WORCESTER COUNTY PLANNING COMMISSION AGENDA

Thursday, April 3, 2025

- A. Seaside Christian Academy – Major Site Plan Review

- A. Rezoning Case No. 447 – 22.86 acres from C-2 General Commercial District to R-4 General Residential District, Tax Map 21, P/O Parcel 66, Lot 1 and Revised Parcel B, Racetrack Road (Maryland Route 589), Ocean Pines, MD, Maryland Medical Owners II, LLC and Maryland Medical Owners III, LLC, Property Owners and Hugh Cropper, IV, Attorney

LANDSCAPE PLAN

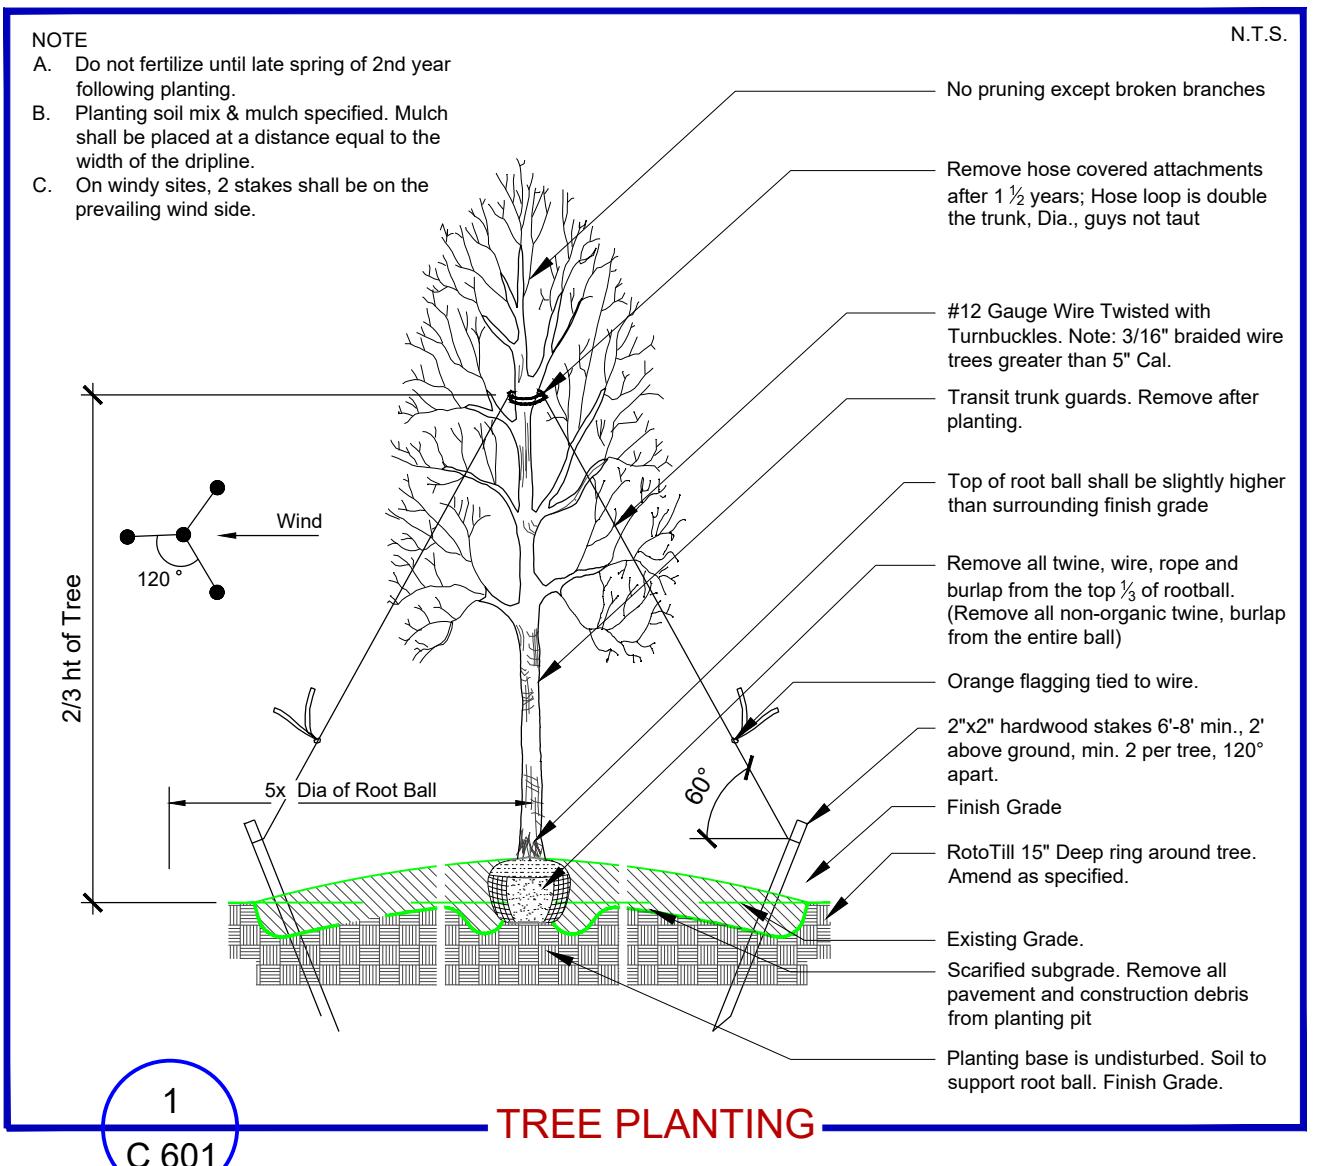
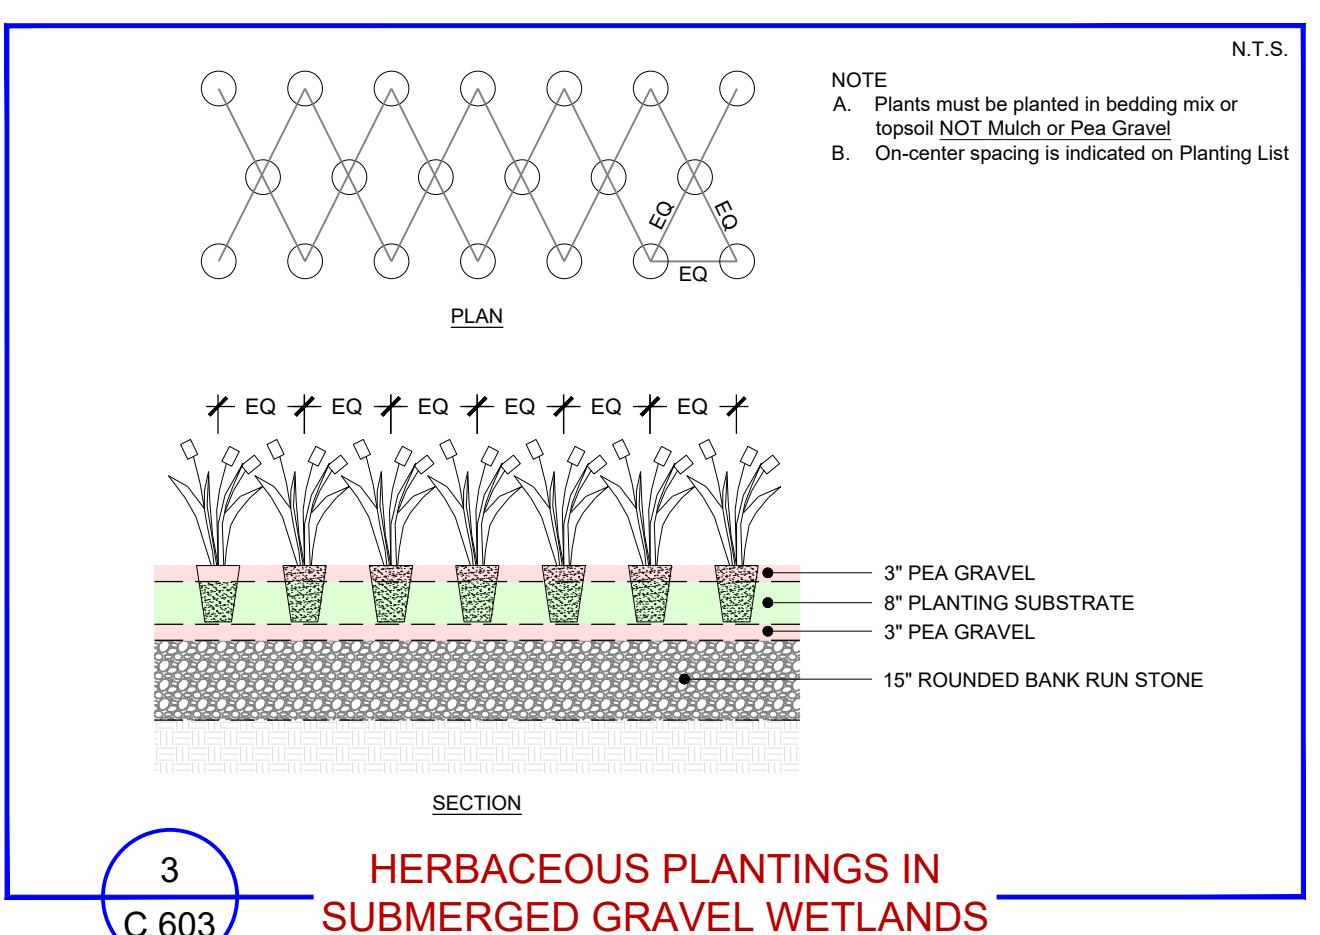
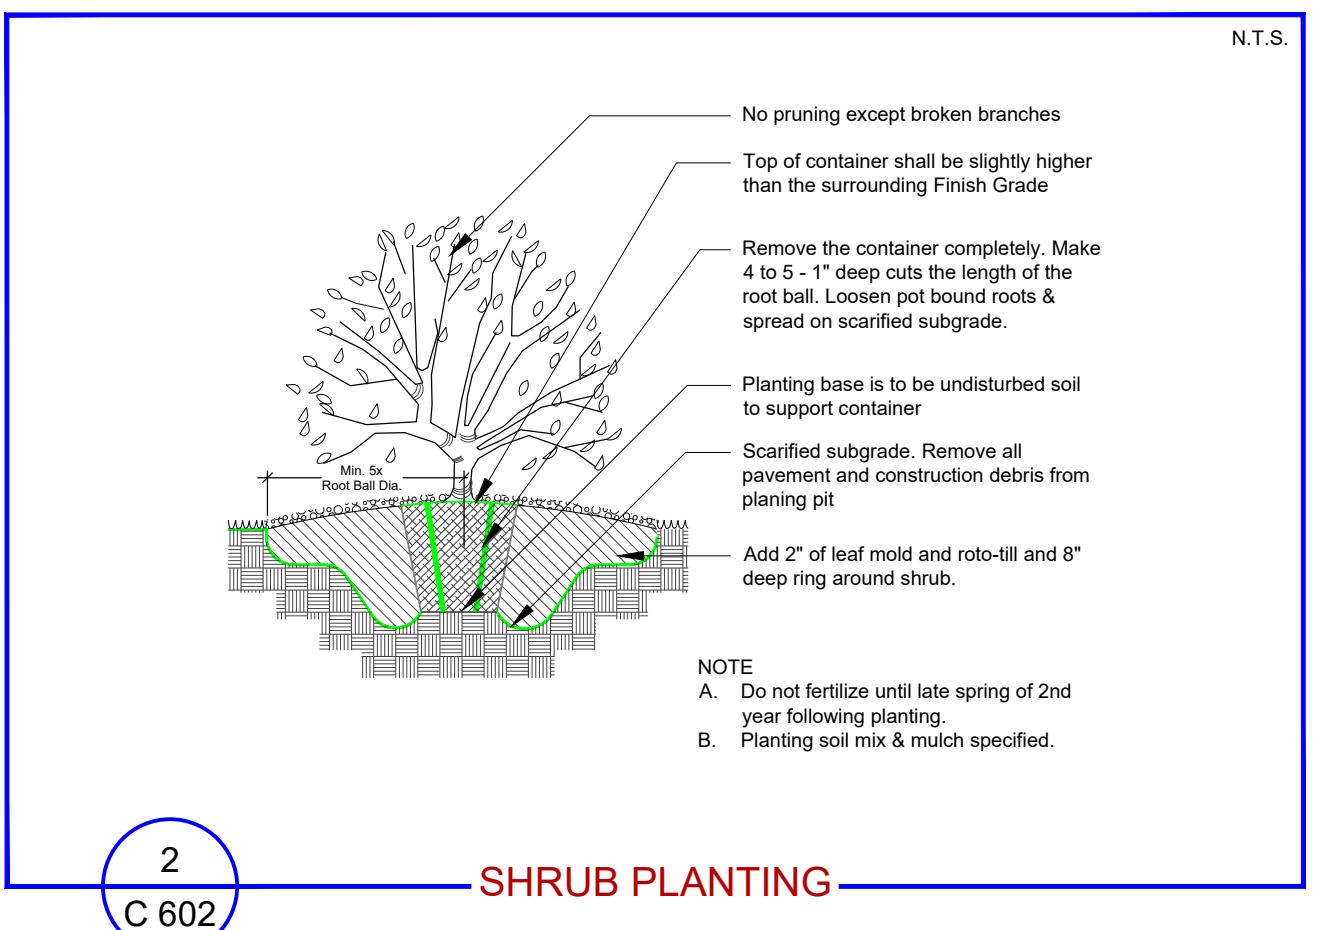
LANDSCAPING: A landscape plan has been provided which consists primarily of native species, including Crape Myrtles, Bayberries, and Maiden Grass. As discussed in the 3/12/2025 TRC meeting, a mix of evergreen shrubs has been proposed to enhance the buffer between the development and the Fox Chapel Subdivision abutting the property.

An automatic landscape watering system is proposed on the site plan as required by the Code as shown on Sheet C600. A maintenance and replacement bond for the required landscaping is mandatory for a period not to exceed two (2) years in an amount not to exceed one hundred and twenty-five percent (125%) of the installation cost. A landscape estimate from a nursery will also be required to be provided at permit stage to accurately determine the bond amount.

T.R.C. - 3/12/2025

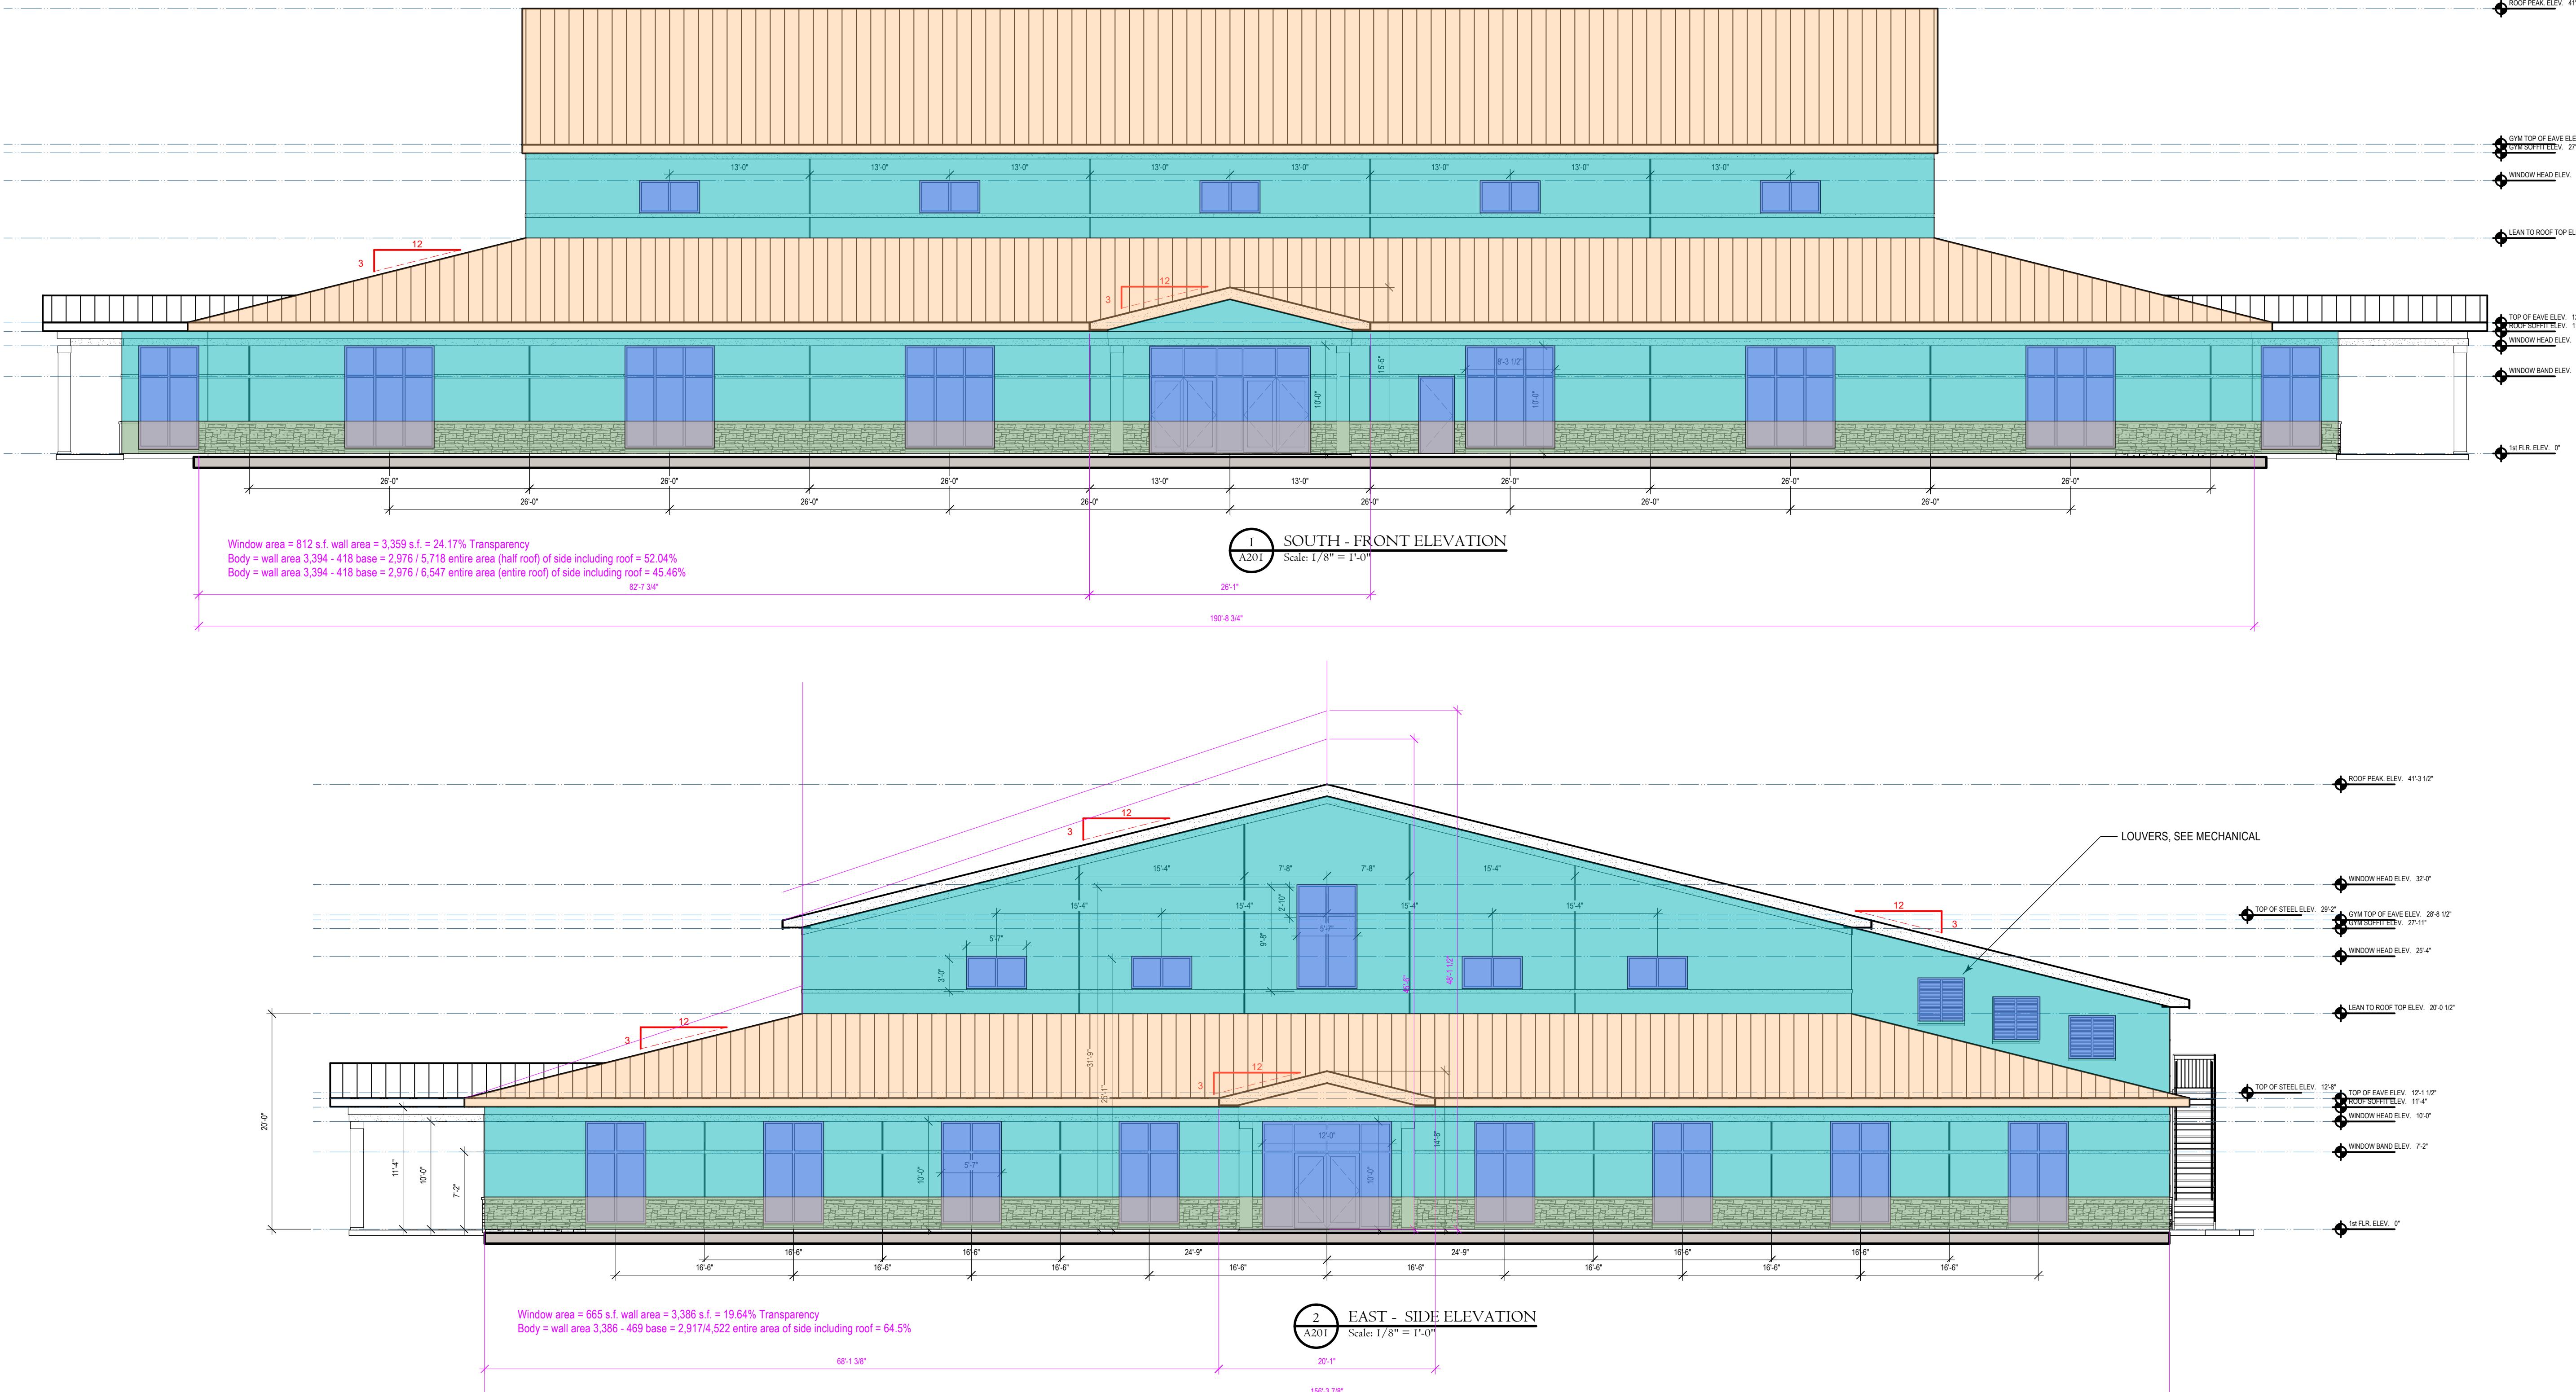
- (B) No interruption in the width of the façade greater than 60 feet in width;
- (C) Facades greater than 60 feet in width should have a wall plane projection or recess with a depth of 2 feet or 3% of the façade whichever is greater and with a width of at least 12 feet or 20% of the façade whichever is greater;
- (H) Transparent features need to be included over a minimum of 25% of the surface;
- (J) The building façade shall have a clearly identifiable base, body and cap with horizontal elements separating these components.

Section 13: Details. A waiver is requested to 13(b)(1) to waive the requirement that building facades must include a repeating pattern in case a detail of a specific element does not repeat every 30' on any one façade.

Section 18. Lighting. The Planning Commission is encouraged to discuss with the applicant if a waiver to 18(b)(5) is needed:

- (5): Wall packs shall be used as special purpose building security lights only. Wall packs may not be used as accent or general building/site lighting. They shall be fully shielded and direct light downward only and shall be equipped with true cut-off type bulbs. Spillover of light and glare from wallpacks shall not be visible at any property line. Lumen output should be two thousand or less.

It is recommended that the Planning Commission review the materials provided and determine if the waivers requested are appropriate for the proposed watercraft services facility.
